Subject: AP1000 Response to Request for Additional Information (SRP 6)

RAI-SRP6.2.1.1-SPCV-07 R2

# AP1000 TECHNICAL REPORT REVIEW

RAI Response Number: RAI-SRP6.2.1.1-SPCV-07  
Revision: 2

Figure D-4

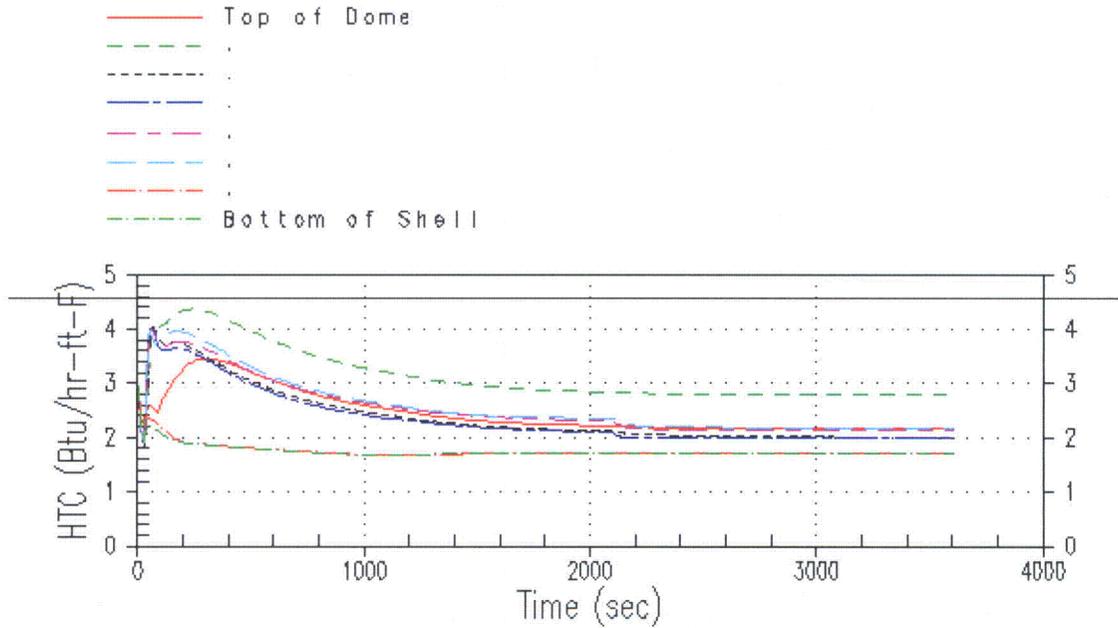
- d) In response to RAI-SRP6.2.1.1-SPCV-01 and -03, Westinghouse provided values calculated by WGOthic for the heat transfer coefficients of the containment shell, baffle, and shield building. Explain how these were derived (specific time point and WGOthic conductor) and why they differ from the heat transfer coefficients reported in the referenced calc notes (where at 3600 sec, h-outside containment shell =5.2 B/hr-ft<sup>2</sup>-°F and h-inside containment shell =1.6 B/hr-ft<sup>2</sup>-°F).

- c) The DCD figure 6.2.1.1-11 time scale is in error and should be corrected. See DCD revisions section below.
- d) The heat transfer coefficients provided in the RAI responses were taken from different thermal conductors than the heat transfer coefficients plotted in the calnote. The heat transfer coefficients calculated by W Gothic for one "stack" of shell thermal conductors (PCS shell from the dome to the operating deck) from the steady-state run are presented in Table D-1. The heat transfer coefficients calculated by W Gothic for one stack during the transient are provided in Figures D-1 and D-2.

Figure E-1

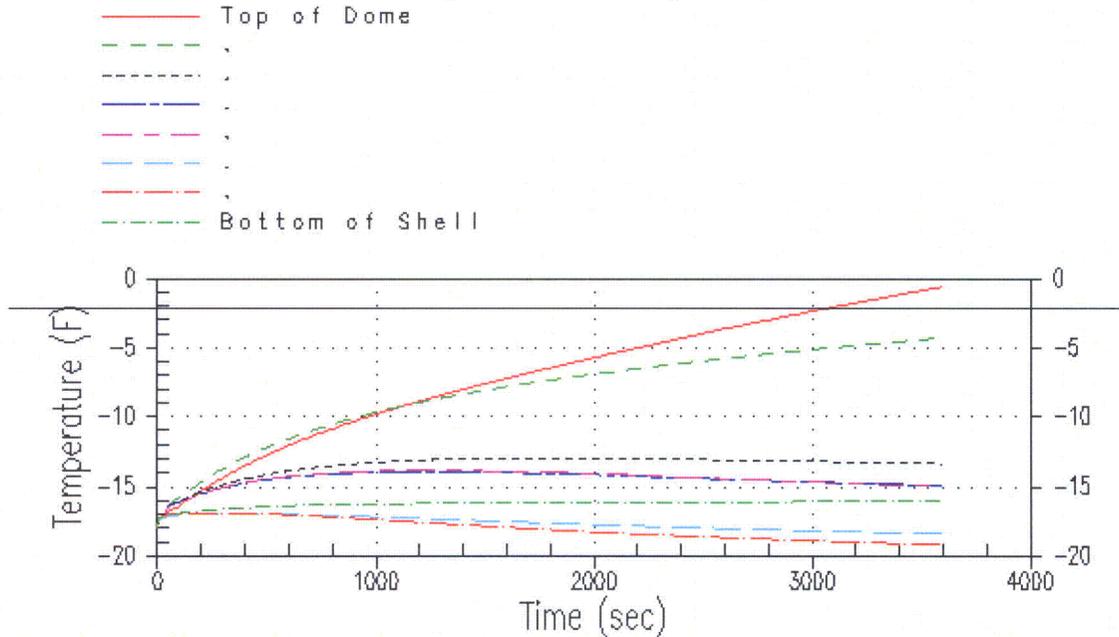
- e) Although the referenced calc-notes state that the containment shell temperature was initially set to -18°F for the second part of the analysis (actuation of fan coolers after steady state operation at low temperature), the WGOthic model included in the Appendix has the shell conductors set to 69°F. Please provide a plot of the containment shell temperature versus time for this transient.

- e) The containment shell initial temperatures were appropriately set to  $-18^{\circ}\text{F}$  in the transient WGO THIC run of APP-MV50-Z0C-020. The initial temperature was determined from a conservative estimate of the average temperature of the shell in the steady-state run. The temperature response of one PCS "stack" during the transient is provided in Figure E-1.

Figure F-1

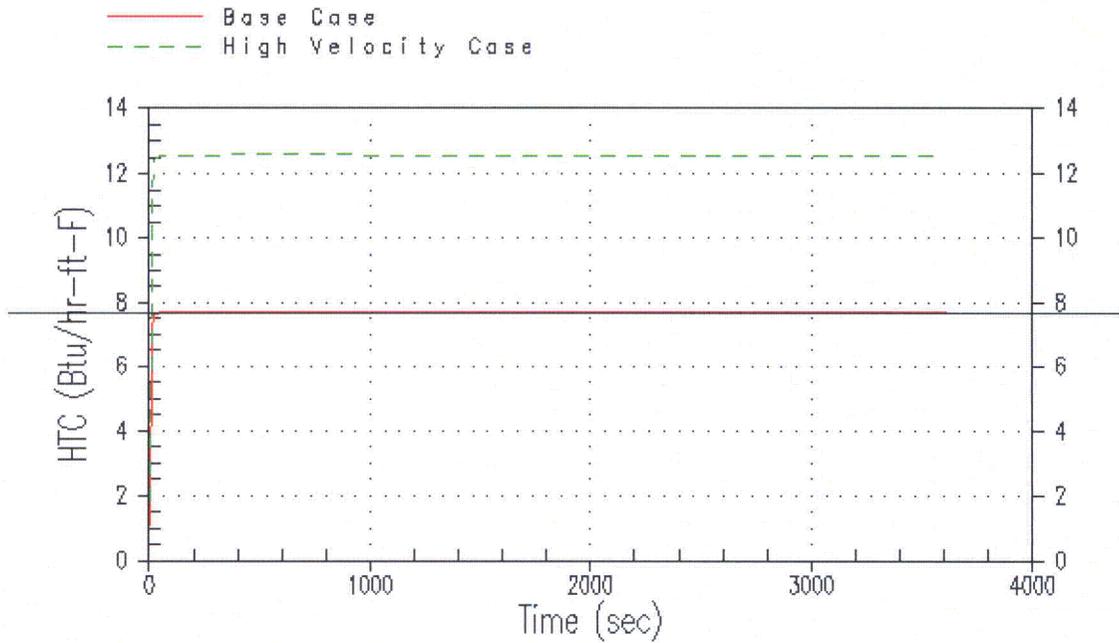
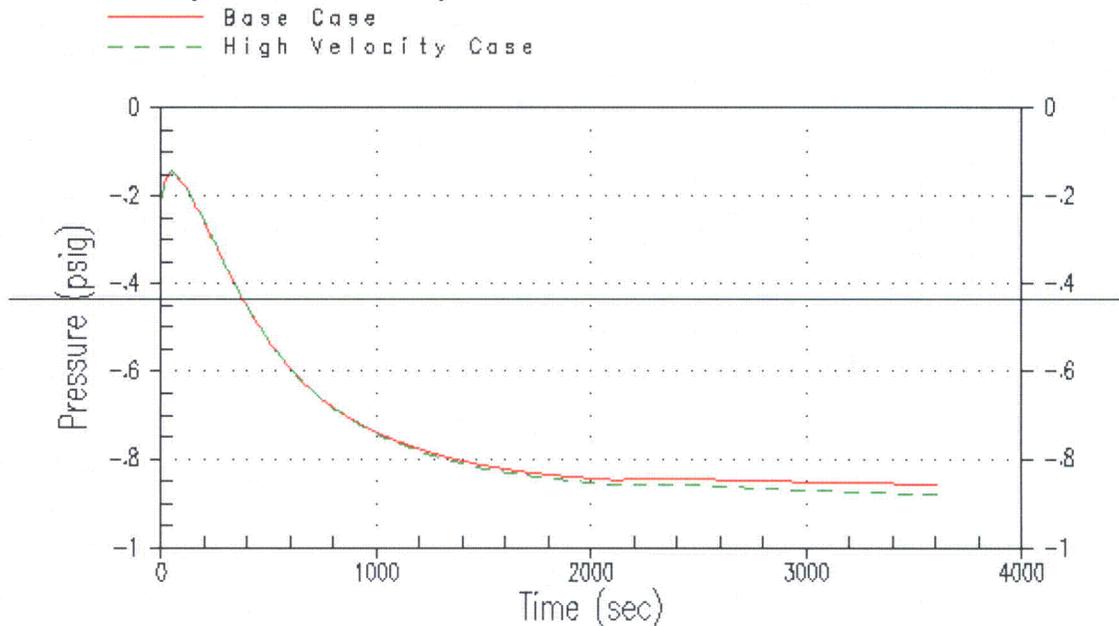
- f) In response to RAI SRP 6.2.1.1-SPCV-04, Westinghouse states that the changes to the shield building air inlets make the air velocity in the annulus less dependent on external wind speed. In the original design, the assumed 48 mph wind speed was modeled with a 25 mph annulus velocity. For the new shield building design, describe how annulus velocity was modeled and how this correlates to a 48 mph wind speed.

- f) The wind-induced annulus velocity does not have a significant impact on the calculation with respect to the annulus velocity induced by the gas density difference in the PCS. In the APP-MV50-Z0C-020 analysis, WGOthic calculates the velocity through the annulus, which is 25 ft/s (17 mph), based on density differences. A sensitivity analysis was run increasing the heat transfer coefficients in the PCS annulus by 1.62 in the transient pressure case. The Nusselt number is a function of the velocity (Reynold's number) raised to the 0.8 power, so the resulting heat transfer coefficient corresponds to an annulus velocity of 36.8 ft/s (25 mph). The WGOthic heat transfer coefficients on the outer shell surface increase as shown in Figure F-1. The impact on the peak external pressure is 0.024 psi (Figure F-2), which is a 3% increase in the external pressure.

Figure 6.2.1.1-11

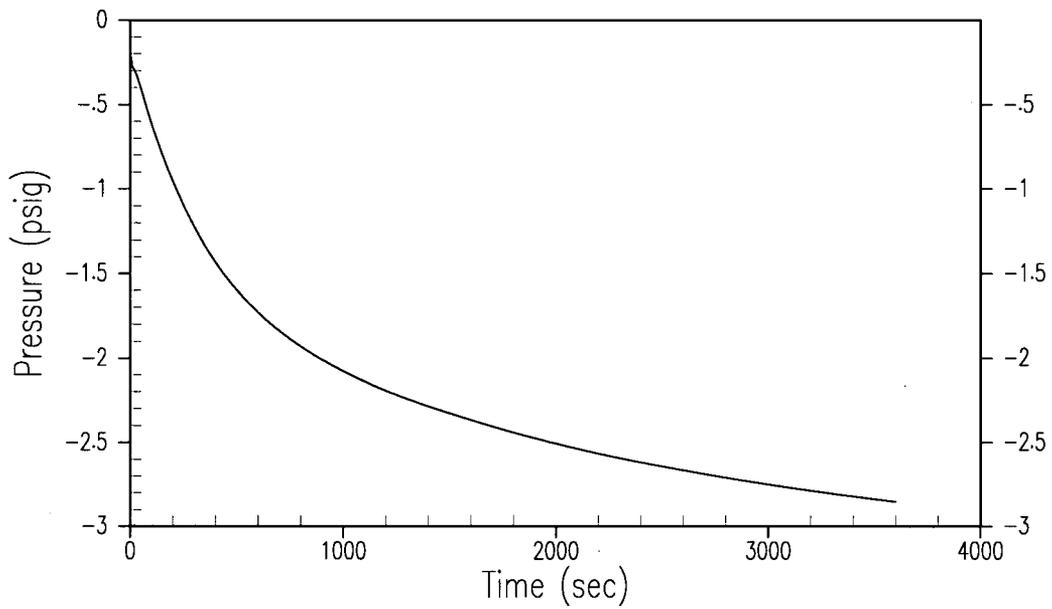
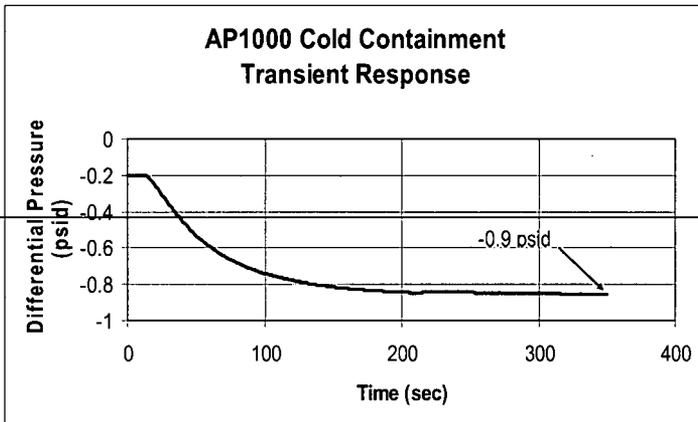
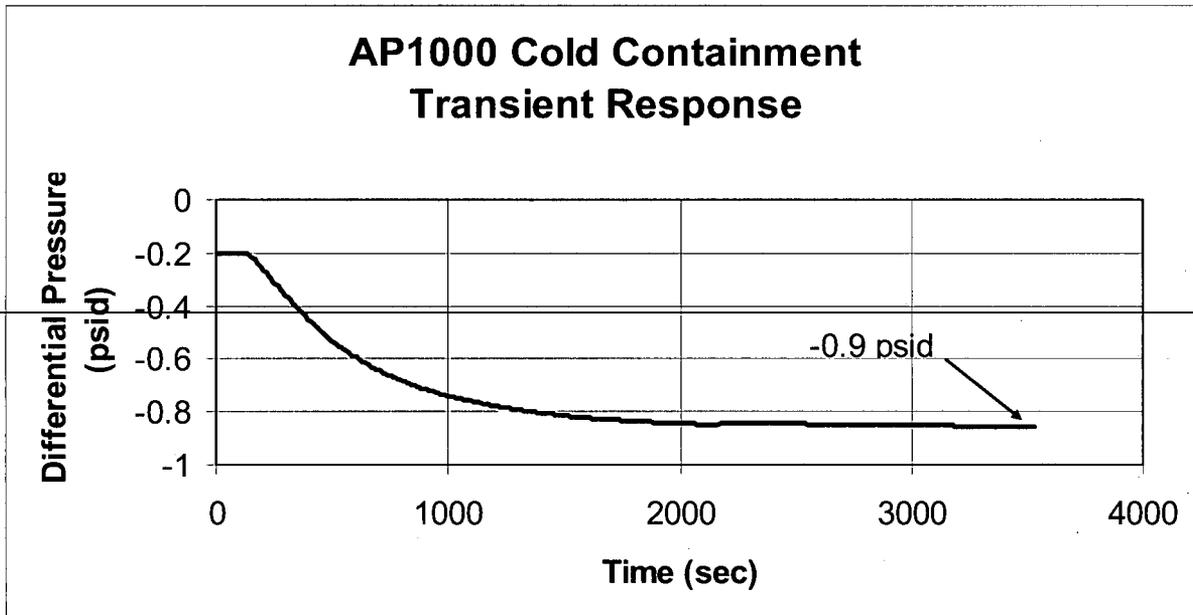
- c) There is a 10x difference in time scale between DCD Figure 6.2.1.1-11 and the associated data points from Appendix E of the referenced calc notes. Please resolve the discrepancy. If the scale in the DCD Figure is correct, justify why analysis ended after 6 minutes.

The mark-up shows the changes to Section 6.2.1.1.4 and Figure 6.2.1.1-11 based on Revision 15 of the DCD.

Replace the current DCD Rev. 17 Figure 6.2.1.1-11 (shown here)

With this version:
